3ST (2 & 4 pole) Performance Comparison

CURVE / C3STPERF

3500 RPM - 2 POLE

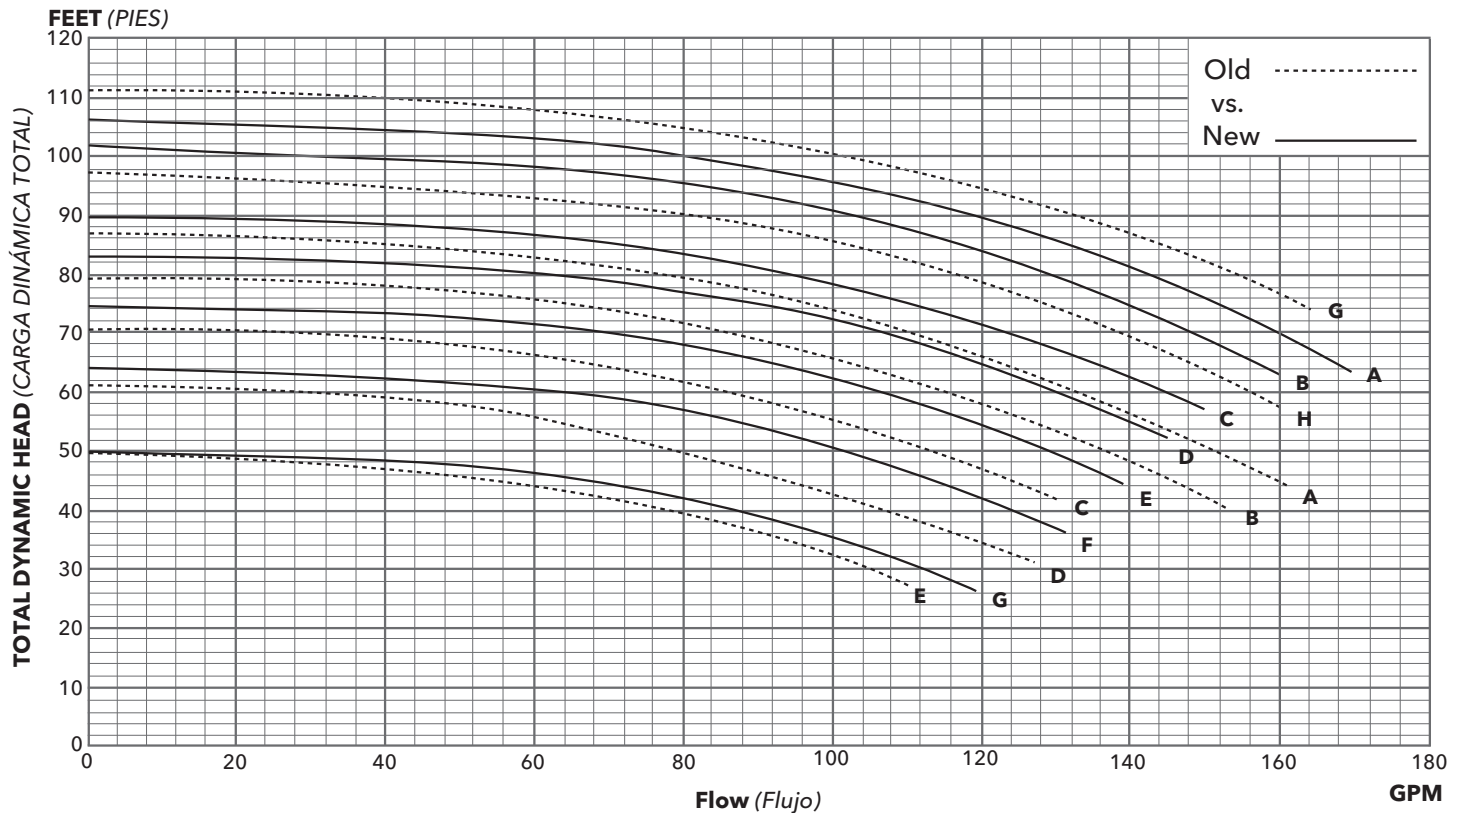
Previous Impeller	Previous Impeller Dia. (in)	New Impeller	New Impeller Dia. (in)
A	4.75	A	5.13
B	4.63	B	5.00
C	4.38	C	4.75
D	4.06	D	4.50
E	3.63	E	4.38
F		F	4.06
G	5.38	G	3.63
H	5.00

1750 RPM - 4 POLE

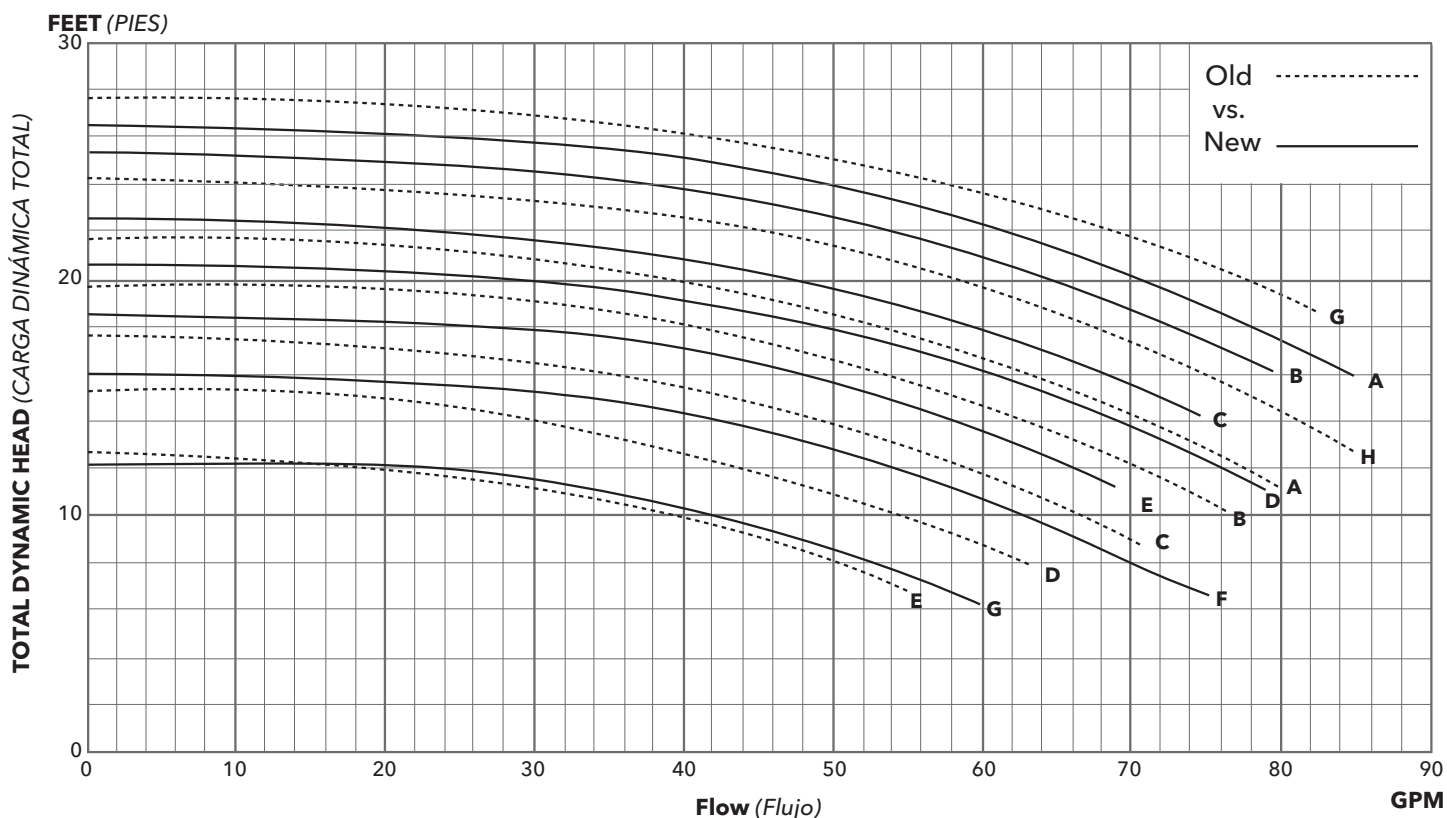
Previous Impeller	Previous Impeller Dia. (in)	New Impeller	New Impeller Dia. (in)
A	4.75	A	5.13
B	4.63	B	5.00
C	4.38	C	4.75
D	4.06	D	4.50
E	3.63	E	4.38
F		F	4.06
G	5.38	G	3.63
H	5.00
